Office Action Summary

10/511,070

JONES, STEVEN VICTOR

DETAILED ACTION

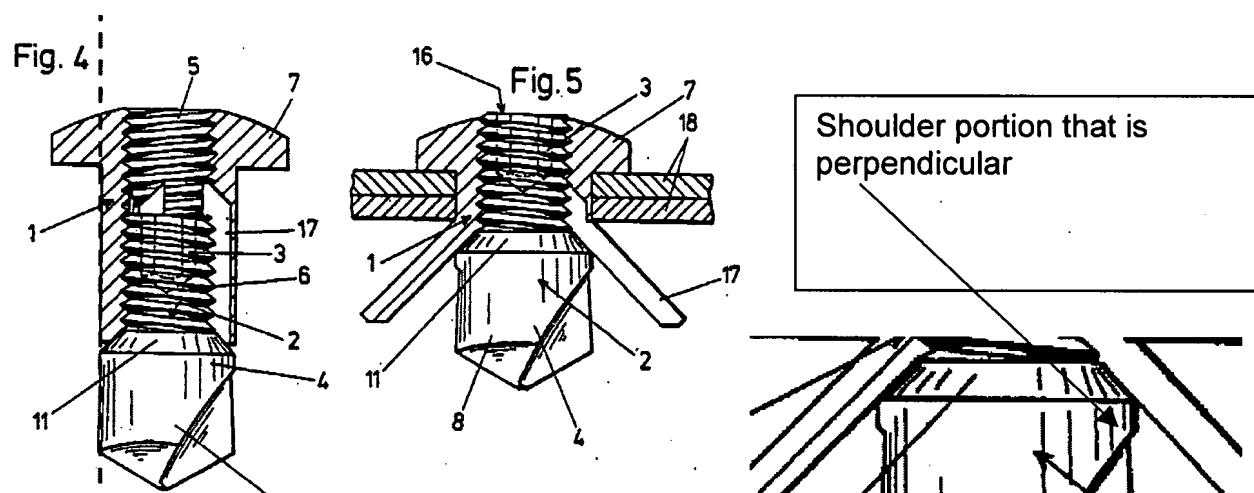
RE claims 1,12 and 19: Palm teaches a peel type blind rivet with an elongate tubular body 1 having a shank (Fig 1 and 4) and preformed head 7 and expandable portion (end including 12 and 17) at end opposite head. The expandable portion comprises a bore which is a constant inner diameter (Figures copied below), and an external surface with a constant outer diameter and the body defines a plurality of slots 12 (Column 5 lines 27-61) which terminate remote from said first end. The mandrel has a stem extending co-axial through said tubular body, with a mandrel head unit 4 with maximum external diameter larger than the body internal diameter, and the mandrel head has a shoulder portion in contact with the opposed end defining a bearing surface (Fig 4) which is ***substantially*** perpendicular to the stem.

Further regarding claim 12 and 19: The detail above shows a perpendicular shoulder portion - it is inherently in contact with the opposed end when the mandrel is 1st pulled thru the opposite end.

Re claim 9: The embodiment of Figs 1-3 shows a breakneck or reduced diameter portion, 10. Note that in Fig 4, the shoulder is the slightly enlarged area as shown in the detail above, and in this case, the reduced diameter portion is portion 11.

Re claim 10: The max diameter of the mandrel head is equal to the external diameter of shank, see examiner's dotted line in Fig 4 above and Fig 1 below..

FIG. 12

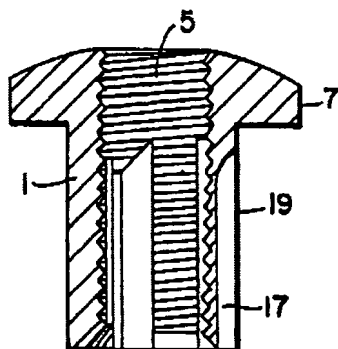
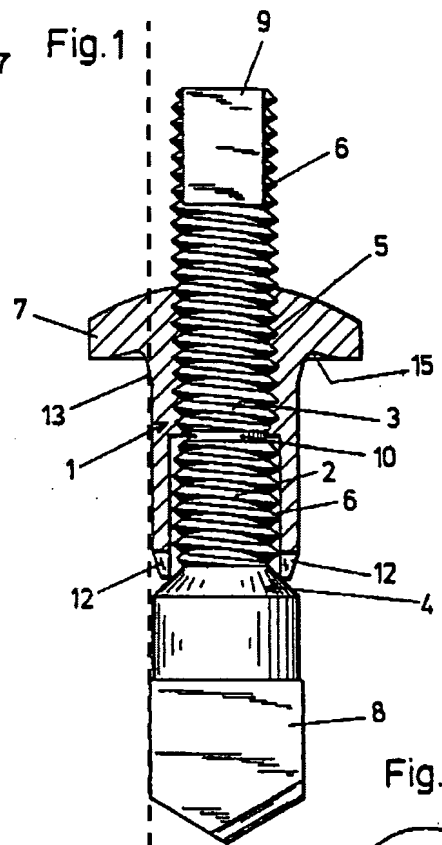
Re claims 3-6, 14-17: The slots are shown as described in Figs 12-15, noting that column 5 lines 27-61 states the grooves 17 can be through slots.

Palm shows slots 12/17 extending in a width from an outer surface to an inner surface of said tubular body in Fig 12 and col 5 lines 26-61, and further teaches in Palm col 5 that the sidewalls can be curved:
